Maxtor Corporation
500 McCarthy Boulevard
Milpitas, CA 95035 USA

To: T10 SAS Protocol Working Group
Contact: Mark Evans
Phone: 408-894-5310
Email: mark_evans@maxtor.com
Date: 12 July 2004

Subject: SAS-1.1, ST_T (transport layer for SSP target ports) state machines

Figure 116 — ST_T (transport layer for SSP target ports) state machines

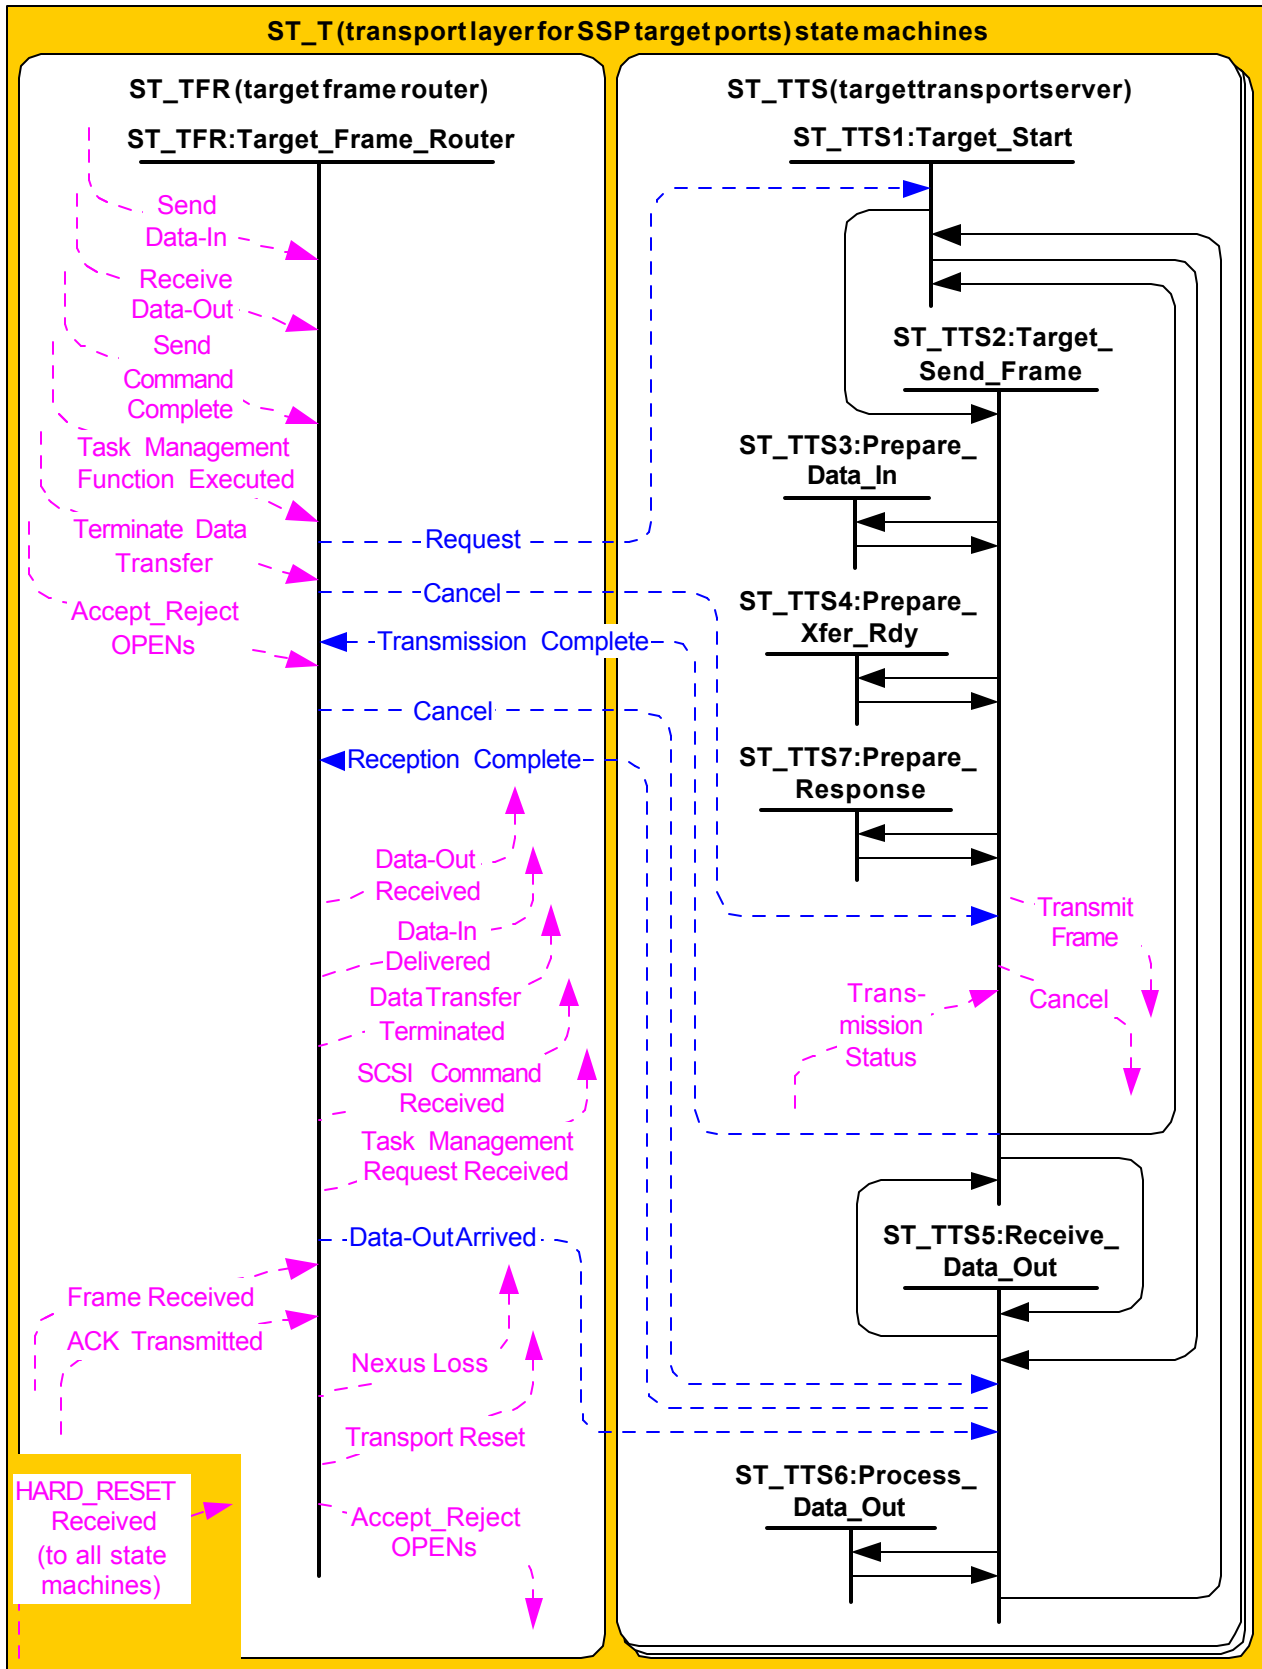
This proposal evolved from adding transport layer retries and the new protocol service, Terminate Data Transfer, to the SSP transport layer state machines. While including these elements, changes were made to simplify and clarify the description of these state machines. These changes include having all communication with the target's SCSI application layer be processed by the target frame router state machine, having a virtual target transport server state machine for each tag, and having the target transport server state machines be persistent between power cycles.

Having all communication with the SCSI application layer be processed by the target frame router state machine provides the ability for that state machine to maintain context for all tasks in process so that it can abort tasks as necessary. Having target transport servers for each tag provides the ability for one state machine to maintain context to process all elements of a task (e.g., XFER_RDY transmission, data transfer, and response). Having the target transport server state machines be persistent between power cycles simplified their description.

Revisions 1 and 2 of this proposal includes corrections to some Request (Send Transport Response) messages, clarification of overlapped tag responses, and other minor editorial corrections.

Figure 116 shows the ST_T state machines.
